SUBJECT: ISSUANCE OF AMENDMENT NO. 57 TO FACILITY OPERATING LICENSE
NO. NPF-29 - GRAND GULF NUCLEAR STATION, UNIT 1, REGARDING
FUEL CYCLE 4 RELOAD (TAC NO. 71438)

AMENDMENT NO. 57 TO FACILITY OPERATING LICENSE NO. NPF-29 - GRAND GULF

ATTACHMENT TO LICENSE AMENDMENT NO. 57

SUPPORTING AMENDMENT NO. 57 TO FACILITY OPERATING LICENSE NO. NPF-29

FIGURE 3.2.1-1 MAPLHGR vs AVERAGE PLANAR EXPOSURE FOR SINGLE LOOP OPERATION, 8X8 FUEL

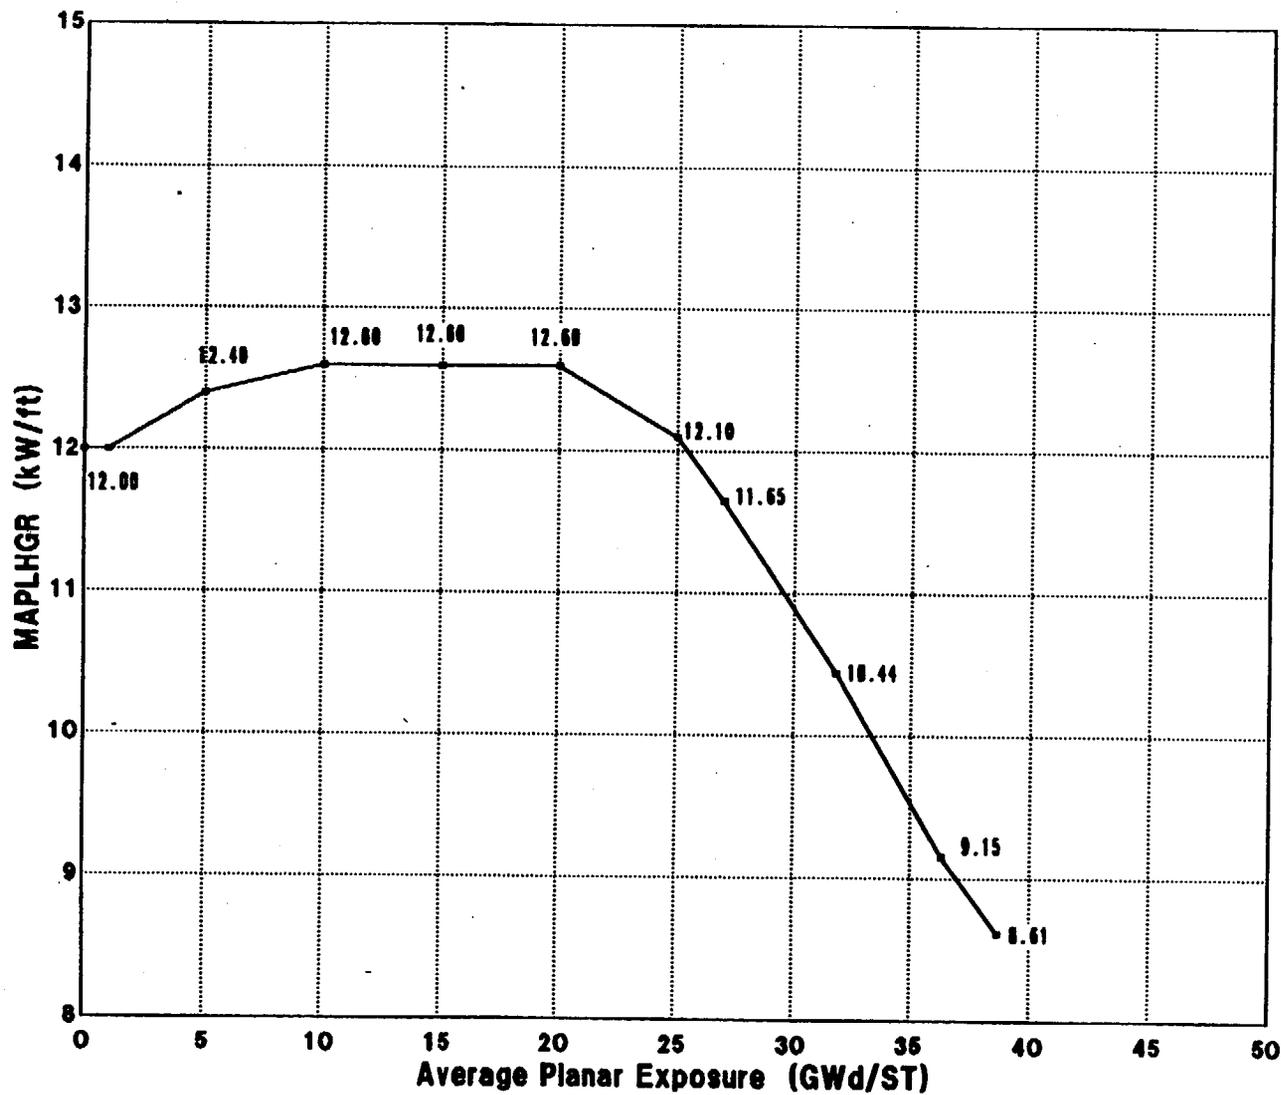
1. Addition of the maximum axial planar linear heat generation rate (MAPLHGR) curve for the new 8x8 fuel.
2. Revision of the single loop MAPLHGR curve.
3. Change of flow and power dependent thermal limits for off-rated condition transients.
4. Addition of linear heat generation rate (LHGR) and MAPLHGR curves for the 9x9-5 LTAs.

A MAPLHGR curve for the new 8x8 and the 9x9-5 fuel has been added. The single loop operation limit is added for the new 8x8 fuel and the 9x9-5 lead assemblies. Figures 3.2.1-1, 3.2.1-2, 3.2.3-1, 3.2.3-2 and 3.2.4-1 reflect these changes.

- a) for 8x8 ANF fuel types - the limit shown in Figure 3.2.1-1 as multiplied by the smaller of either $MAPFAC_f$, $MAPFAC_p$ or 0.86; and
- b) for 9x9 ANF fuel type the limit determined in Figure 3.2.1-1e as multiplied by the smaller of either $MAPFAC_f$, $MAPFAC_p$ or 0.86.
